April 17, 2008

Re: Bradley Square DRI #612

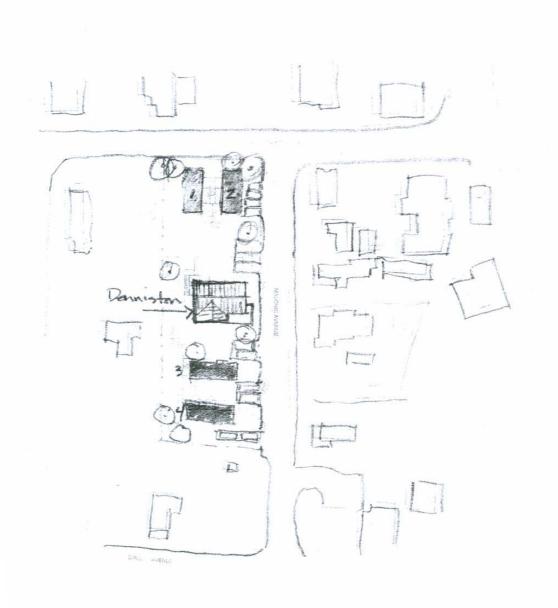
If the buildings were reduced in scale as mentioned it would allow for eight one-bedroom units in the four new buildings; one 3 bedroom in the Denniston building and potentially four market rate retail spaces. Alternatively the two buildings facing Dukes County Ave could have two market rate retail spaces and four one-bedroom units while the two buildings facing Masonic Ave. could each have two 2-bedroom units or a combination of 1- and 2-bedroom units. Splitting the buildings allows each to be built under the one- and two-family building code as opposed to the commercial code, which should be a cost savings.
